Amendments to the Drawings:

Reply to Office Action Mailed September 14, 2007

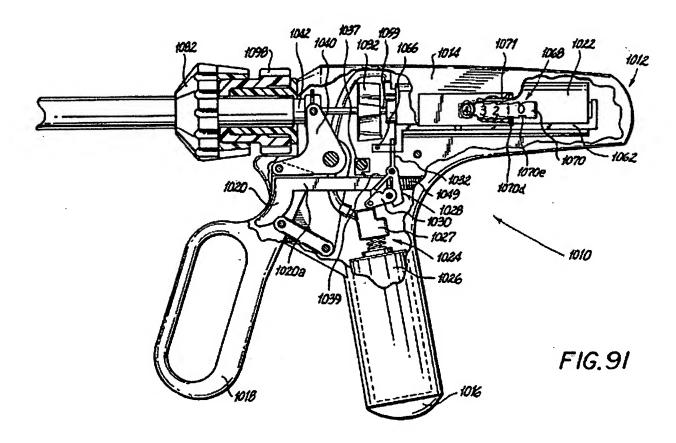
The drawings have been objected to under 37 CFR 1.83(a) as failing to show every feature of the invention specified in Claims 11 and 12. In response to this objection, FIG. 3 has been amended to include a schematic representation of a motorized mechanism recited in Claims 11 and 12. Clear support for this amendment to FIG. 3 can be found on page 14, lines 15-20 of the specification as originally filed and in originally filed Claims 11 and 12. More specifically, on page 14, lines 15 and 16, for example, the specification recites that "It is further envisioned that the input action to store energy may be motor driven." It is respectfully submitted that FIG. 3 as amended does not include any new matter. It is also respectfully submitted that the schematic representation of the motor and power supply satisfies the requirements of 37 CFR 1.83(a) with respect to the mounting structure recited generally and specifically in Claims 11 and 12.

The attached sheet of drawings includes changes to FIG. 3. This sheet, replaces the original sheet including FIG. 3.

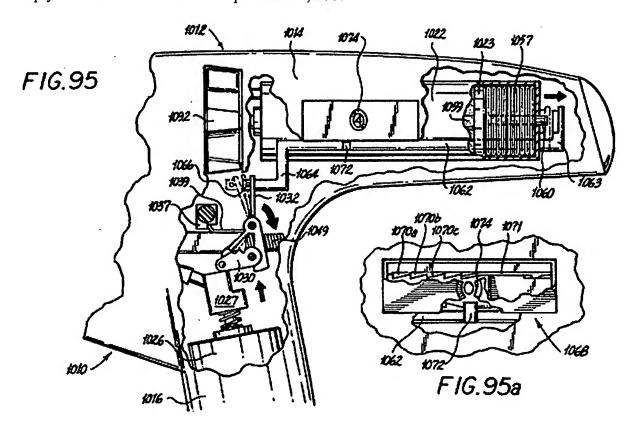
Green describes a self contained gas powered endoscopic surgical apparatus provided for placing lateral lines of surgical fasteners into body tissue. Green provides that when the piston has completed its stroke, as shown for example in FIG. 95 reproduced below, a stem 1060, which extends proximally from the piston 1023, will interact with an outwardly depending portion 1063 of a release shaft 1062 and will urge the release shaft 1062 in a proximal direction. Release shaft 1062 includes a depending distal portion 1064 from which extends a transverse detent 1066. Detent 1066 is dimensioned and configured to interfere with the latching link 1032 and cause the disengagement of the latching link 1032 and the rocker link 1030 after the apparatus 1010 has been actuated. Col. 37, Lines 50 – 60.

Green does not teach, suggest, or disclose the instrument as recited in amended Claim 17. More specifically, Green provides no guidance or motivation for one skilled in the art to include an actuation mechanism *comprising a valve* wherein the valve is operable to control the rate of release of the energy *stored in the spring of the energy storage mechanism*. For this reason, Applicants believe that Claim 17 is patentable over Green and is in condition for allowance.
